**BEFORE THE PUBLIC SERVICE COMMISSION
OF THE STATE OF MISSOURI**

STAFF’S RESPONSE TO GRAIN BELT EXPRESS’ ADDITIONAL INFORMATION

SUBJECT: Staff Response to Grain Belt Express' Additional Information Filed In Response
To Order Directing Filing

File No. EA-2014-0207

Natural Gas Heat Rate Curves (Item 12 (4) of Commission Order)

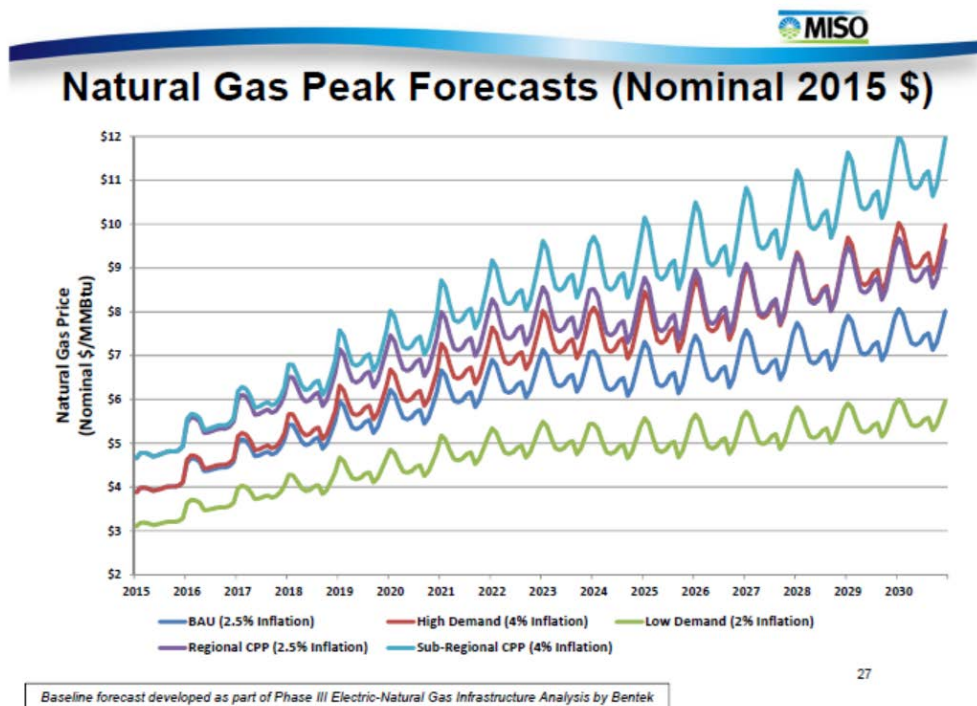
GBE did not incorporate any improvements to its modeling of generator heat rate curves in its revised modeling. GBE's modeling, both direct-filed and revised, uses a horizontal heat rate curve for gas-fired generation. Use of a horizontal curve means that GBE assumes a gas-fired plant will have the same efficiency across all levels of production. This is like assuming you will experience the same miles per gallon in your car whether you are traveling 2 mph, 55 mph, or 120 mph. This is not a reasonable assumption.

Because the level of gas generation is significantly different between GBE's modeled scenarios, Staff reasonably expects that varying the heat rate curves to a more reasonably-estimated slope would significantly impact the outcomes of the scenarios.

Staff does understand that GBE does not have access to the quality of generator and transmission line data that MISO and other RTO's possess. Staff recommended that GBE revise its modeling to incorporate "[r]epresentative (if estimated) heat rate curves instead of average heat rates across all capacity stages." (Staff Comments, 4.c.) Based on discussions with Mr. Cleveland, Staff understood that GBE's revised modeling would use at least a straight-line diagonal curve, if not a quadratic curve, based on publicly-available representative curves.

GBE's revised modeling assumes horizontal heat rate curves for gas generation. GBE's assumption of a horizontal heat rate curve for gas generation is unreasonable, and modeling relying on this assumption is unreliable for purposes of estimating the impact of the Project on plant-level operations.
